**ADDENDUM NUMBER TWO
TO THE REQUEST FOR PROPOSALS FOR OFFICE SYSTEMS FURNITURE DESIGN,
PROCUREMENT, AND INSTALLATION
LAKE COUNTY BOARD OF COMMISSIONERS AND LAKE COUNTY SHERIFF'S OFFICE
ISSUED SEPTEMBER 13,, 2024**

The County hereby amends the Request for Qualifications as follows:

TB-11

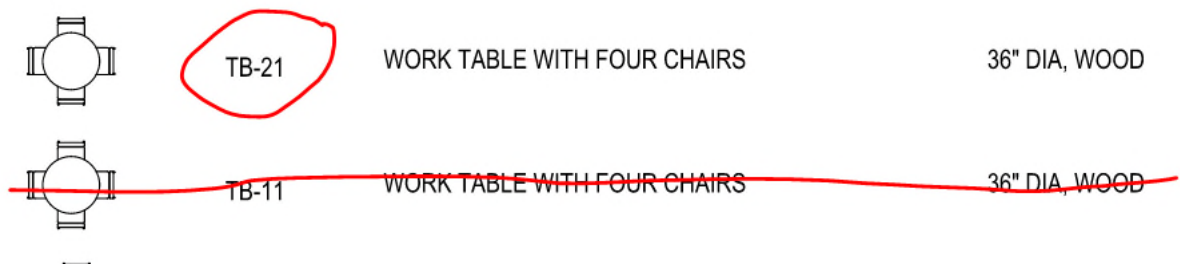
RFI No. 8: TB-11 is on the Furniture Key twice but each line has a different description. Please clarify.

Response: Please follow the floor plans. TB-11

TB-11 tagged with icon of work table with four chairs is miss labled and should be TB-21
